Item 4.**Modification Application: 525-529 George Street, Sydney - D/2019/758/A**

File No.: D/2019/758/A

Summary Recommendation: The Section 4.55 application is recommended for approval.

Figure 5: Approved axonometric (left) and proposed axonometric (right) viewed from George Street, proposed areas of modification identified as hatched

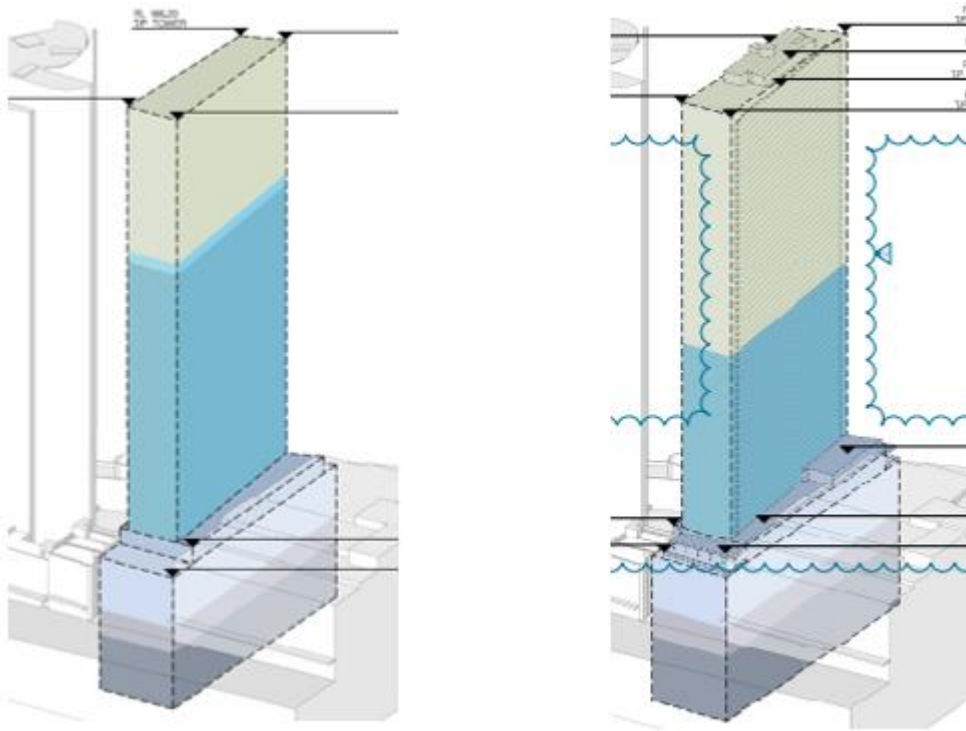
- adjust the set-back podium envelope to Kent Street to accommodate the relocated pool terraces (maximum height of RL48.35);
 - adjust the podium envelope to accommodate awnings and balustrades to the level four terraces fronting both Kent Street and George Street;

- modify the tower envelope to the south by 550mm to accommodate tower structure;
 - modify the tower envelope to the north by 300mm to incorporate a structure for public art; and

- modify the tower envelope to incorporate plant and lift overrun to communal open space, noting the maximum height of the envelope has increased from RL169.12 to RL172.51.

Figure 12: Proposed northern elevation - area in red identifies location of amended podium height from RL 44.00 (approved) to RL 45.00 (proposed)

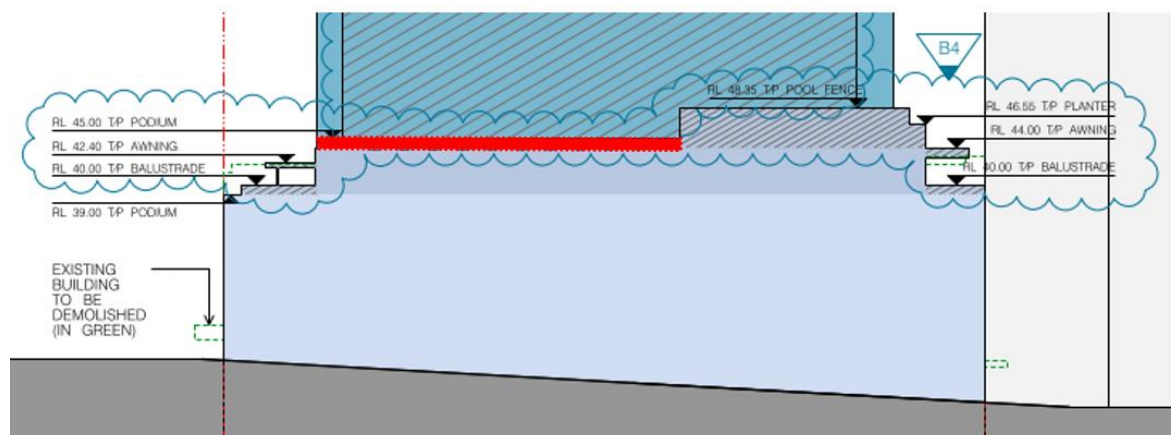
Modification to amend the top of podium from RL44.00 to RL45.00 to align with the adjacent approved development at 505-523 George Street.

30. The modification seeks to provide a modified podium height of RL 45.00 to the area to the immediate northeast of the tower, adjacent to 505-523 George Street. The amended height matches the height of the podium at 505-523 George Street approved by D/2019/857.

31. This modification does not result in any change to the George Street frontage height and the additional bulk will not be visible from the public domain below.

34. The amended podium height in this location will not have an unacceptable impact on the adjoining site at 505-523 George Street and the modification is supported.

Figure 13: Proposed George Street elevation - yellow outline identifying approved envelope at 505-523 George Street, with red line denoting approved podium height (RL 45.00) which is consistent with the proposed height of the podium adjacent to 505-523

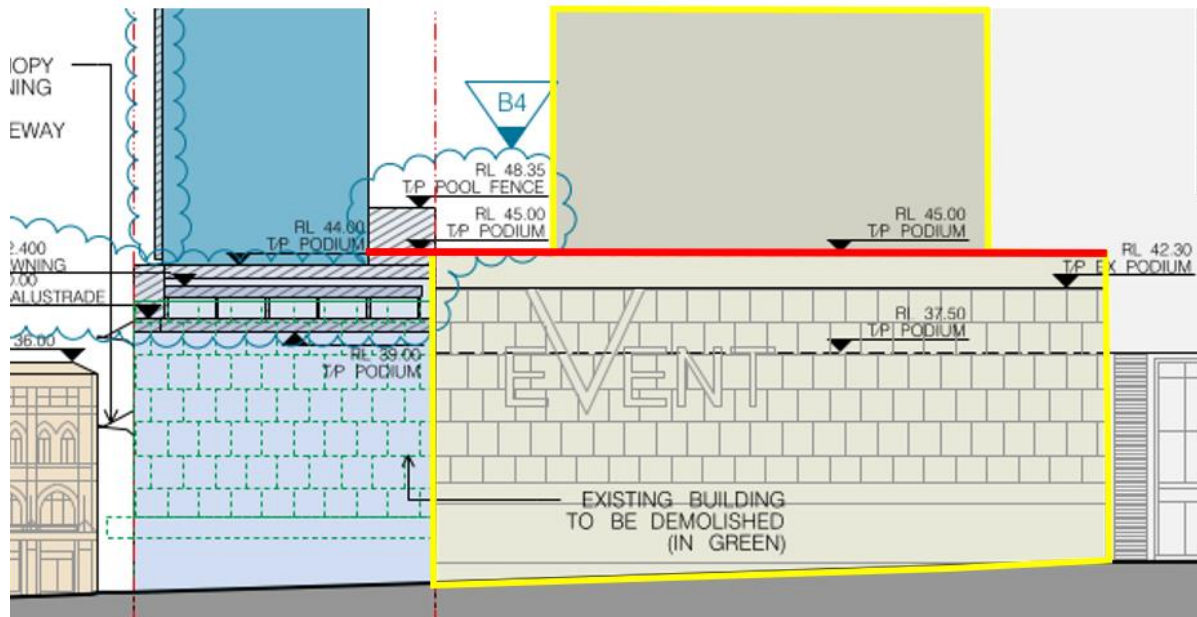
33. The figures below depict the location of the amended podium height and identify its location comparative to the approved development at 505-523 George Street.

Figure 14: 3D study of detailed design development application viewed from Kent Street looking north. Location of proposed amendments to the podium to facilitate balustrade and awning identified in red and approved development at 505-523 George Street.

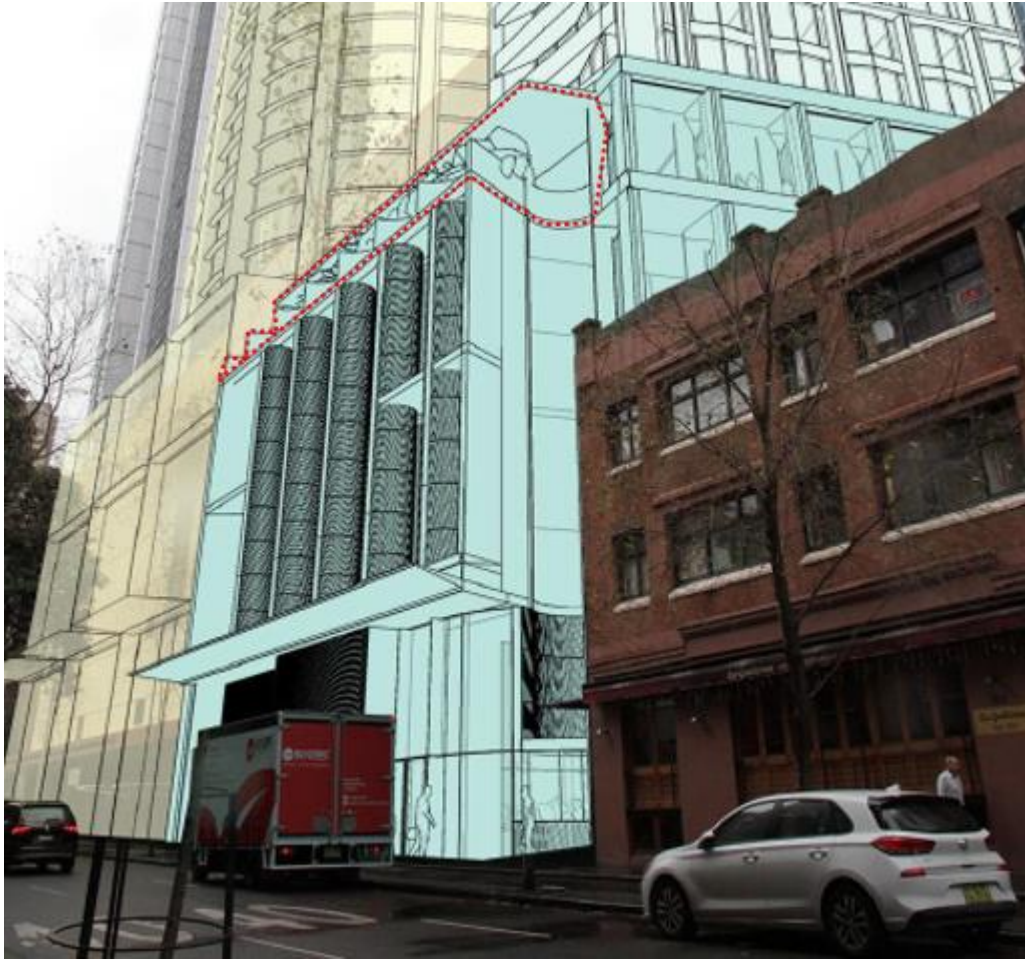
37. The modifications result in an increase in the Kent Street frontage height by 1m from RL39.00 to RL40.00 to permit a balustrade around the external terrace.

38. Section 5.1.1.1 of the SDCP 2012 requires a maximum street frontage height of 25m to Kent Street. The approved envelope frontage height to Kent Street is approximately 22.65m and the proposed frontage height (including the balustrade) will remain below 25m in compliance with the DCP.

39. When viewed in the context of Kent Street, the podium and the awning (RL 44.00) will remain lower in height than the podium approved at 505-523 George Street which has a height of RL45.00. This is supported.

40. The modifications will improve the functionality of the external space and will not result in a privacy impact to the approved development at 505-523 George Street.

42. The modification seeks to permit a pool fence with a maximum height of RL48.35 and a planter with a maximum height of RL 46.55 to the top of the north-western extent of the podium. As depicted in the figures above, the encroachments above the Kent Street frontage are not visible from the public domain due to the projecting awning to the level four terrace which shields the setback pool deck.

Figure 18: View E.1 - View Perspective from apartment at Level 46, approved building envelope identified in blue, amended envelope outlined in red

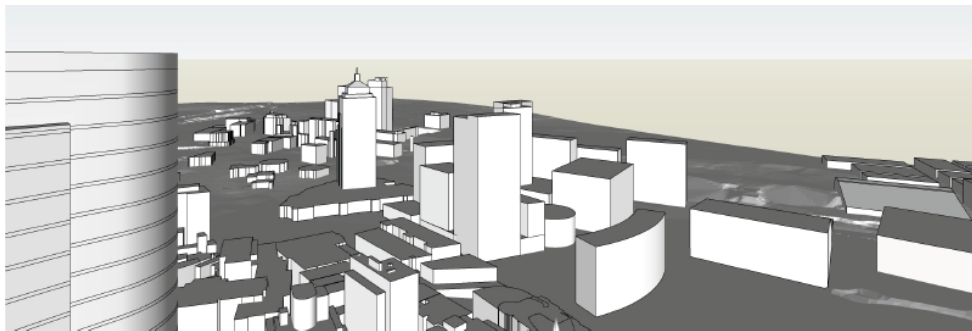
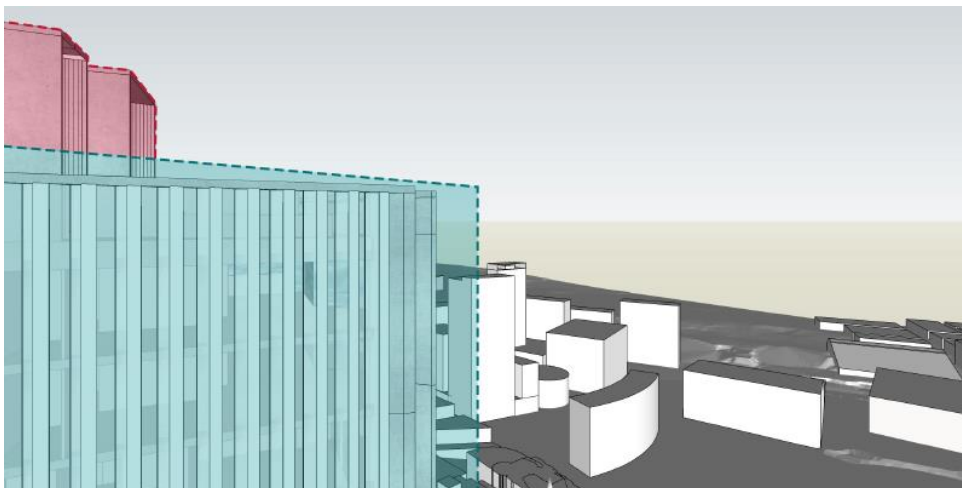
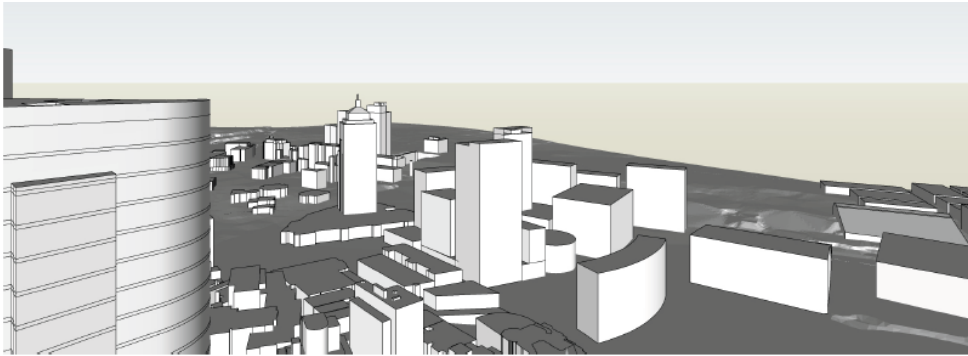
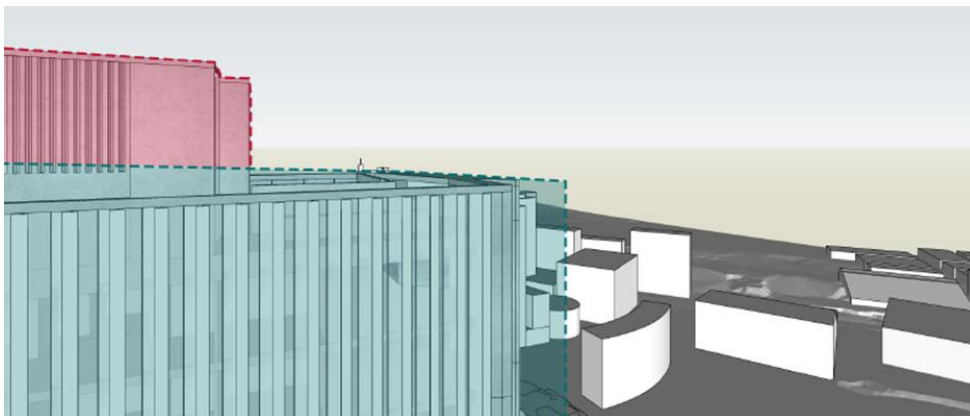
62. This view from the living room looks to the southwest across the proposed development site at 525-529 George Street, as well as to more open vistas across Darling Harbour and the Pyrmont Peninsular. Given the height of the viewpoint, views from this location includes both district views across to neighbouring buildings as well as more distant views to the west, including to Sydney's western suburbs. Importantly, this view is highly urban, with CBD buildings dominant.

63. Views E.1 and E.2 will be impacted by the amended envelope with reduced views to the southwest. However, existing views to the south are largely restricted by the existing Meriton Suites tower. The extent of obstruction is relatively small, and the essence of the view remains. There is no iconic view loss as a result of the proposed modification. The view impact is considered acceptable given district and distant views will be maintained.

Figure 23: View F.1 - View perspective from apartment at Level 46, approved building envelope identified in blue, amended envelope outlined in red

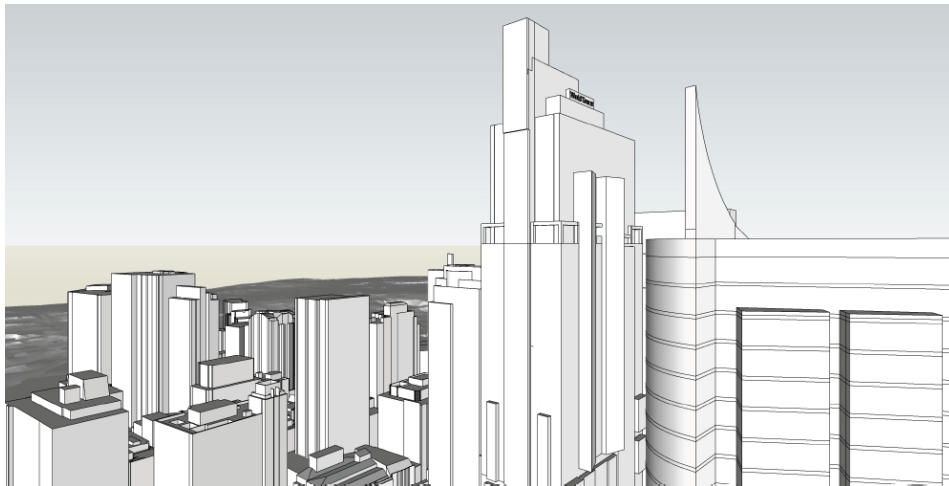
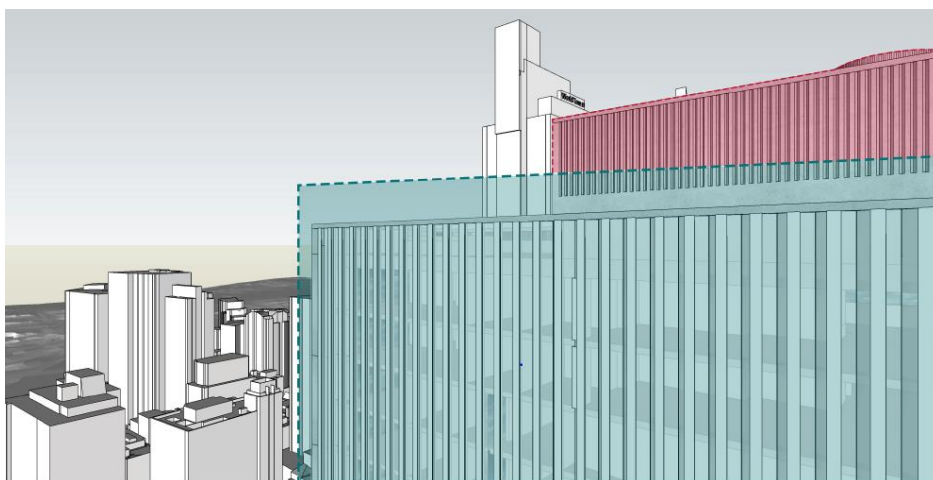
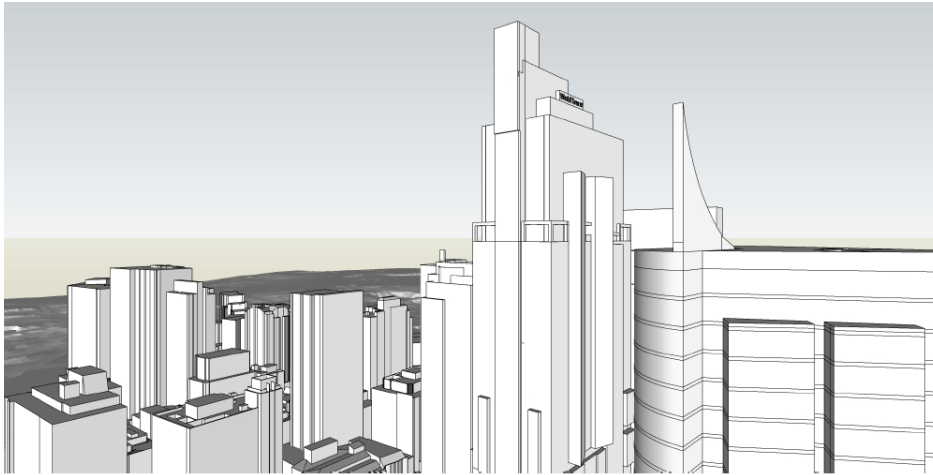
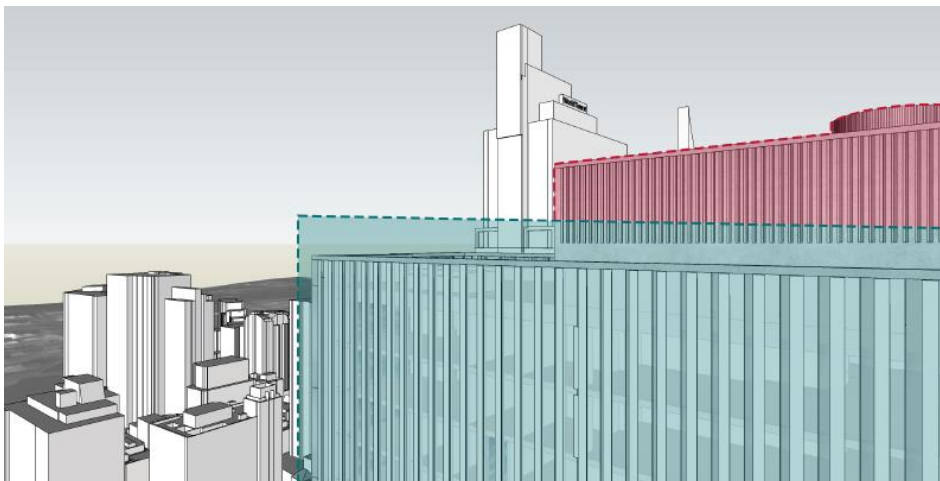
65. This view looks southeast across the site at 525-529 George Street, the Meriton Suites tower behind and buildings behind on Liverpool Street. This view is highly urban and does not contain any iconic features. Due to the height of the viewpoint, views from this location comprise mostly district views across to neighbouring buildings including residential and commercial towers.

66. The proposed development will affect the views from this location by reducing views to the south and southeast. It is noted that views to the south would be largely affected by the existing Meriton Suites tower behind. The amended envelope is considered to have a negligible impact on the nature of this view and district views will be maintained. Further, it is acknowledged that the living room benefits from two aspects and views directly to the east will be maintained and will be unaffected by the proposed amendment to the tower envelope.

67. In summary, the view loss impacts are considered acceptable given there is no impact to any iconic views. The impacted views primarily comprise sky views and views of the tops of nearby buildings. The affected apartments will benefit from good outlook to the east and west and will maintain district views.
